Products Affected:

- D7039 Multiplex (MUX) Expansion Module (v1.04)
- DS9431 MUX Expansion Module (v1.04)
- FPD-7024 Fire Alarm Control Panel (FACP)
- D7024 FACP
- DS9400M FACP

1.0 Issue

Figure 1: Class A Multiple Detector Wiring Fault Locations

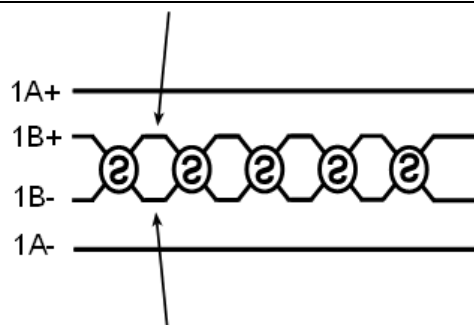
When wired in a Class A configuration, the D7039 or DS9431 MUX Expansion Modules (with v1.04 firmware) might not detect a single wire fault on the B side of the MUX bus when it occurs between the first and second device. For example, if one of the wiring locations indicated in *Figure 1* is open, this issue might occur.

Use a Class B wiring configuration. If this is not possible, replace the D7039 or DS9431 with a v1.05 or later MUX expansion module. To ensure normal operation, replace all v1.04 MUX expansion modules that are installed in Class A configurations as described in *Section 3.0 Replacing the D7039 or DS9431*. After replacing the MUX expansion module, perform the system test described in *Section 4.0 Class A Broken Wire Certification Test* on page 3.

Figure 3: D7039 or DS9431 I/O Module Location

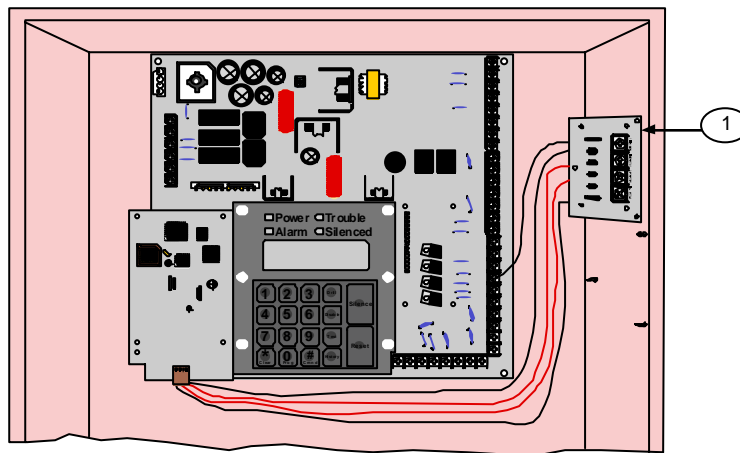
1. Verify that the FACP display shows **SYSTEM NORMAL**.
2. Disconnect the MUX A+ wire from the D7039 or DS9431 I/O Module (refer to *Figure 3*). The FACP display indicates a MUX wiring fault.
Verify that there are no point troubles or fire alarms.
If there are point troubles or fire alarms, the system failed this test. Call Bosch Technical Support at 800-289-0096.
3. Reconnect the wire you disconnected in Step 2 to the D7039 or DS9431 I/O Module.
4. Wait at least 15 sec.
5. Press the FACP's **Reset** button.
6. Repeat Steps 1 through 5 three more times, substituting MUX A-, MUX B+, and MUX B- in Step 2.
7. If the test passes for MUX A+, MUX A-, MUX B+, and MUX B-, the system passes the Class A Broken Wire Certification Test.
8. Walk Test the system.
